CITY COUNCIL ACTION FORM

Department	Presented by	Date
Community Development	Bill Almquist - Comm. Dev. Director	May 18, 2021

First Reading of Ordinance 2021-08: An Ordinance of the City Council for the City of Salida, Colorado Approving a Major Impact Review for a .46 Acre Parcel Located at the Southwest Corner of Highway 291 and West Third Street, Currently Zoned Commercial (C-1) with a Highway 291 Established Commercial Overlay, to Place a Planned Development Overlay on the Property and Approve the Development Plan for a Four-Building Mixed-Use Development (Jane's Place).

Vicinity Map and Site Plan

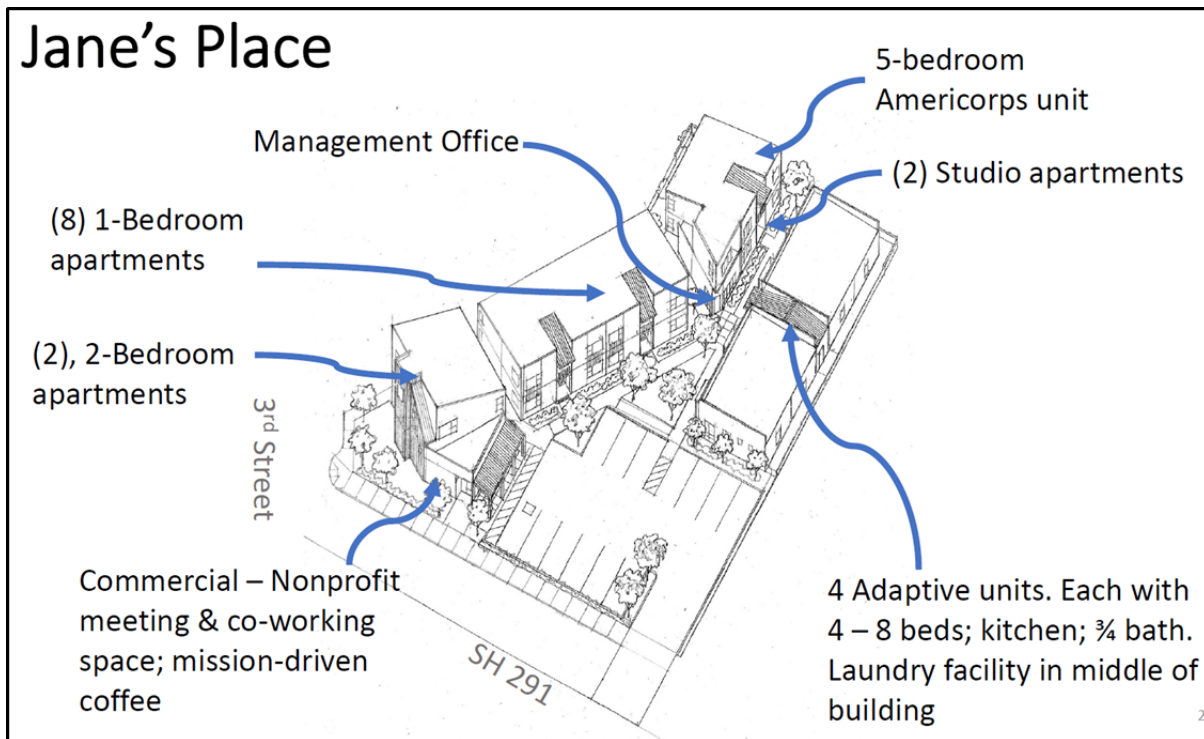
The project does provide a few small private open space area for residents of the development. Staff recommends the following condition of approval (PC recommended changes in red):

- The applicant shall provide a ~~childrens'~~ **flexible recreational** playscape or similar amenities to encourage play and outdoor activity **for people of all ages** in one of the open space areas on the site.
